Board of Architectural Review Work Session
Minutes
Monday, September 14, 2015

William Taylor Plaza Project – Preliminary Design

The developers of a proposed Fairfield Inn at the William Taylor Plaza project met with the Board of Architectural Review at a work session to discuss a preliminary design. The applicants were represented by Charlie Armstrong, Kevin Lewis, Andrew Garlock, D.J. Meagher, and Mike Myers.

SHEET TITLE:
SITE PLAN

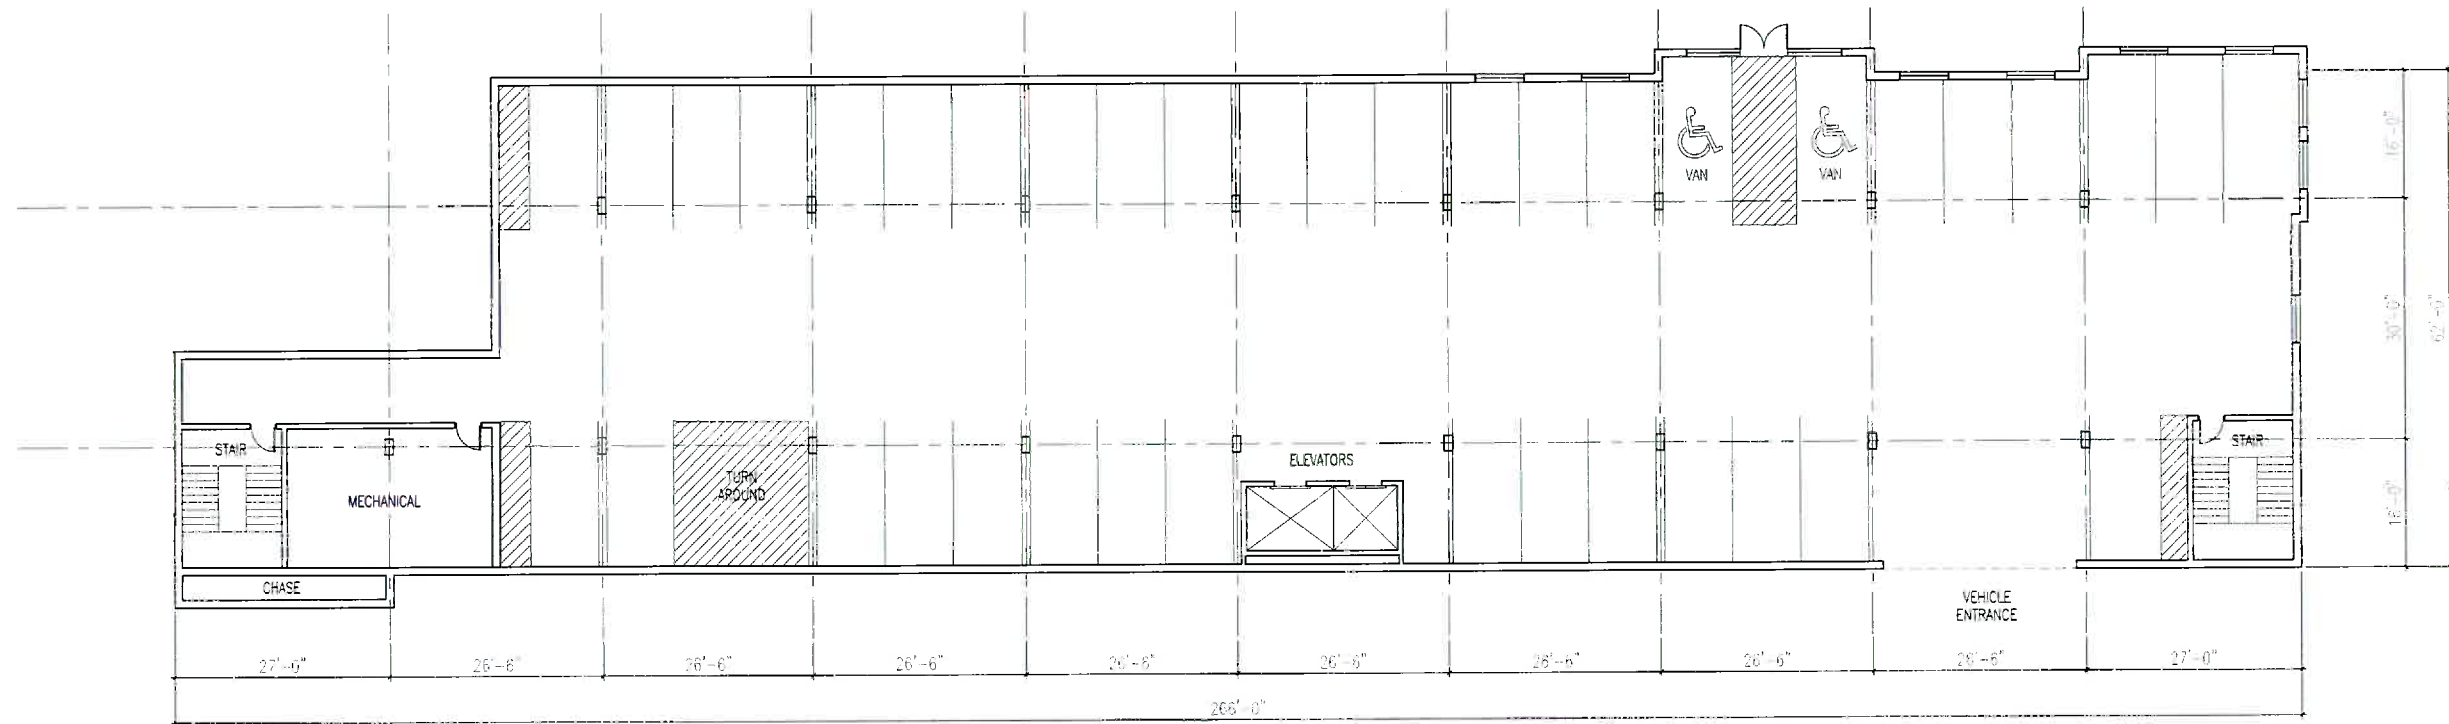
This review is based on the site plan dated 7-29-15 and may not reflect updates to the concept. Our guidelines are not very specific regarding the placement of a building within the site in relationship to topography and other site features, only to surrounding buildings in a historic district. However, the guidelines do state that

- Design new features to assure the preservation of the historic **spatial organization and land patterns**. The orientation of this building is in contrast to historic spatial organization and land patterns in the surrounding historic district. Traditionally, buildings in this historic district were arranged with their longest façade facing the ridge.

If we assume that Phase II may not ever happen, the Phase I building should be turned 90 degrees to face Ridge Street and then its façade carefully designed and modulated to complement the residential scale of the historic district. It would make sense that a hotel, instead of residences, would face onto this busy street. In this way, the hotel would be sited in relationship to the natural ridge in the way that the historic residences were sited. This is a traditional building pattern seen throughout the city in its oldest neighborhoods. As designed, the building does not work well with the topography of the site.

The driveway that enters the site and leads up to the open parking lot is inappropriate for the site because it requires a 20’-tall retaining wall to support it. This is a poor solution and contrasts with the more sensible, hands-off approach to development in drainage areas in the historic district. The location, configuration, height, and materials of the wall are unacceptable in the historic district and the site in particular.

The planting plan proposed for this site is inappropriate for the historic district and does not relate to its context. For example, the street tree planting is composed of crape myrtles, instead of the cherries (or crabapples) that are used across Cherry Avenue—if a small tree is planted, it should match those.

In addition, plantings along the Ridge Street side do not reflect the variety and scale of the rest of the street. At minimum, in addition to crape myrtles, red oak, pecan, maple, ash, Southern magnolia, Eastern red cedar, Deodar cedar, and dogwood are found in the front yards of the historic Ridge Street houses.

I see eight new trees of only two varieties and no shrubs at all. I also see that it is enclosed by a 5' tall "wood picket" fence. What does this look like? Why is it wood picket? Why not a more translucent wire or other material?

Finally, why were the viburnum and witch hazel chosen for the top of the retaining wall? Both of these large shrubs/small trees grow to 8-10' in height, creating what is now, essentially, a 30' high wall above the path that goes to the arboretum. Not a very appealing situation. I also see no attempt to use trees or other plants designed in a layering configuration to mitigate the apparent height of this wall, or plant materials that would be appropriate for the water treatment and retention facilities. In addition, I don't see any precedent for the row of star magnolia along the front of the building or any other plant material here arranged in any way that is either functionally or aesthetically appropriate. Did an engineer design this plan? A local landscape architect who is familiar with vegetation of the area should be designing this landscape.

FIRST FLOOR (LOBBY)

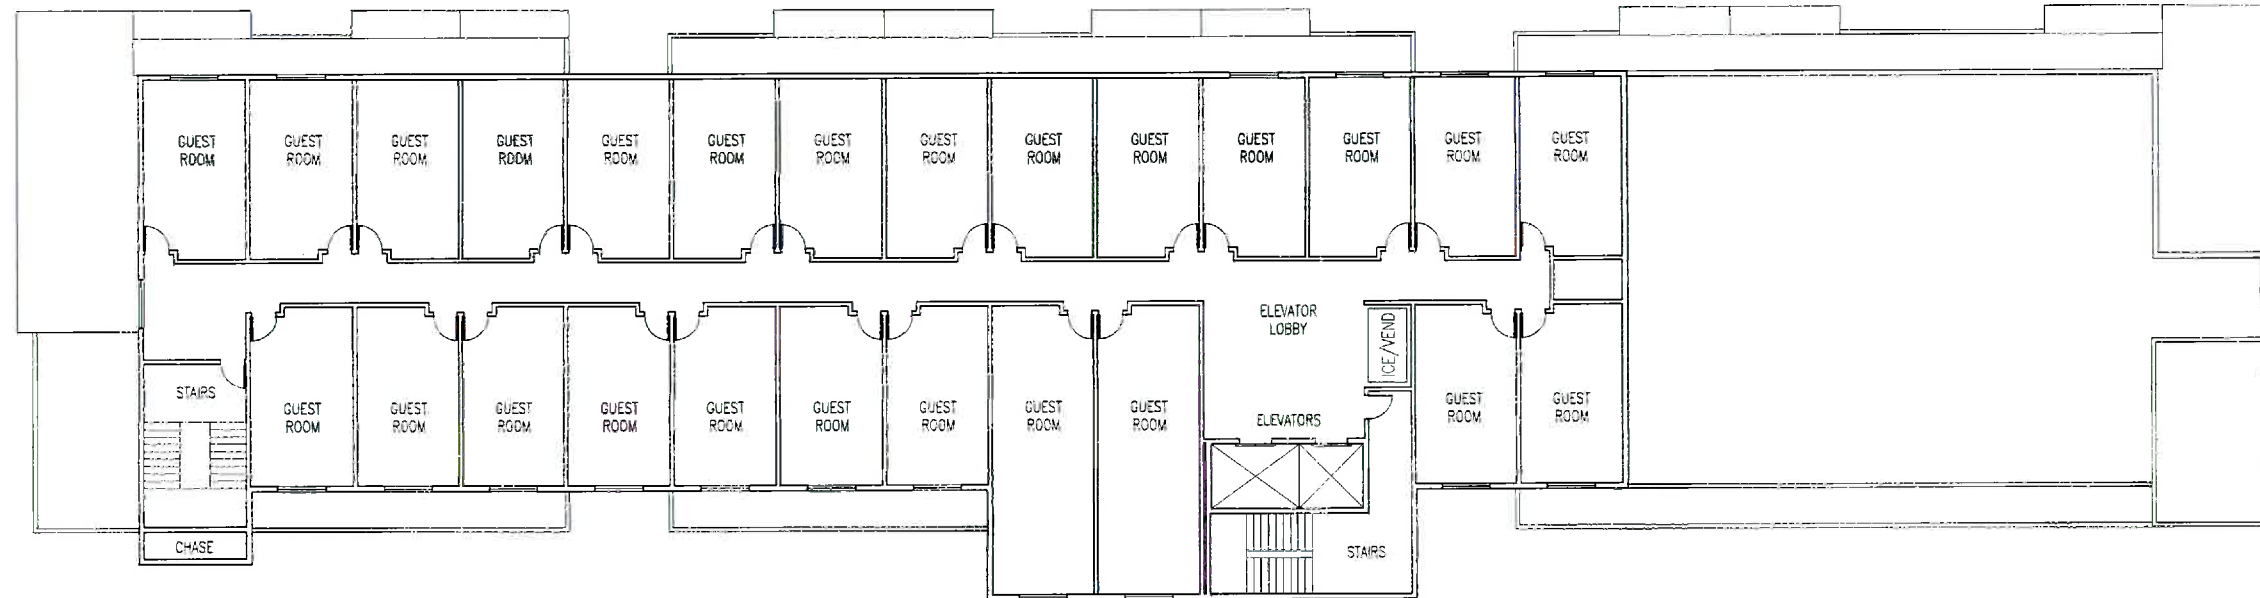
Mr. Mohr said Cherry Avenue at the corner of Ridge is odd. The courtyard does not have to be so large. Plan is not well resolved at lobby. Need to modulate the fenestration. He suggested flip-flopping the fitness with the commercial.

Mr. Lewis summarized that the BAR wanted to know how to get into the lobby going downhill, and how do you resolve the corner space?

EXTERIOR ELEVATION **A**
SCALE: 3/32" = 1'-0"

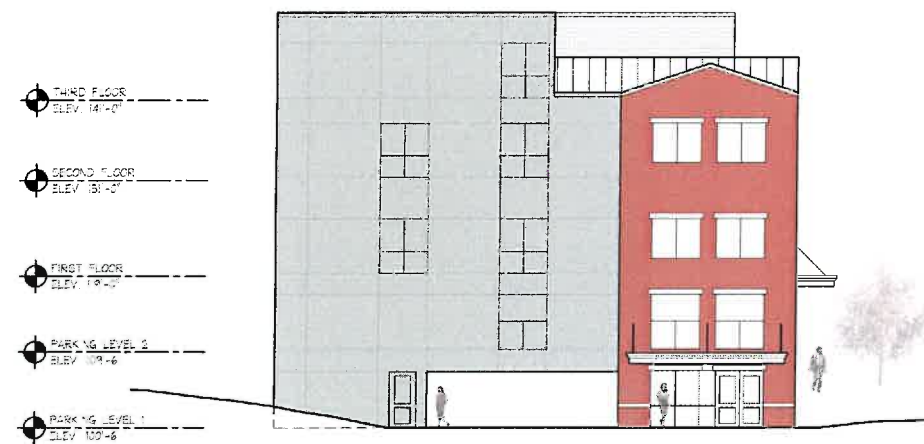
I appreciate what the architect was trying to achieve in modulating the building façade in the new elevation, but the concept we saw in the BAR meeting in August was more appropriate in its massing and roof line to the Cherry Street commercial area than the current concept. The current concept, with its false townhouse fronts, entrance awnings over minor entrances (or no entrance at all), and gables, although an attempt to related to Ridge Street architecture, I can only describe as “hybrid pseudo-historic.” Perhaps a hybrid of the two, that is a more modulated massing, but more contemporary in style, might be more acceptable?

- G. Roof:** The guidelines recommend that neighborhood transitional buildings use roof forms that relate to neighboring residential forms instead of the flat or sloping commercial form. However, in this case, because of the orientation of the major façade to Cherry, this does not seem appropriate. Further down in this section, the guidelines say that “shallow pitched roofs and flat roofs may be appropriate in historic residential areas on a contemporary designed building.” I thought that the designers of this building were headed in the right direction with the roof forms presented in the original design; the new gable form seems silly. I thought the Train and Partners design looked appropriate.
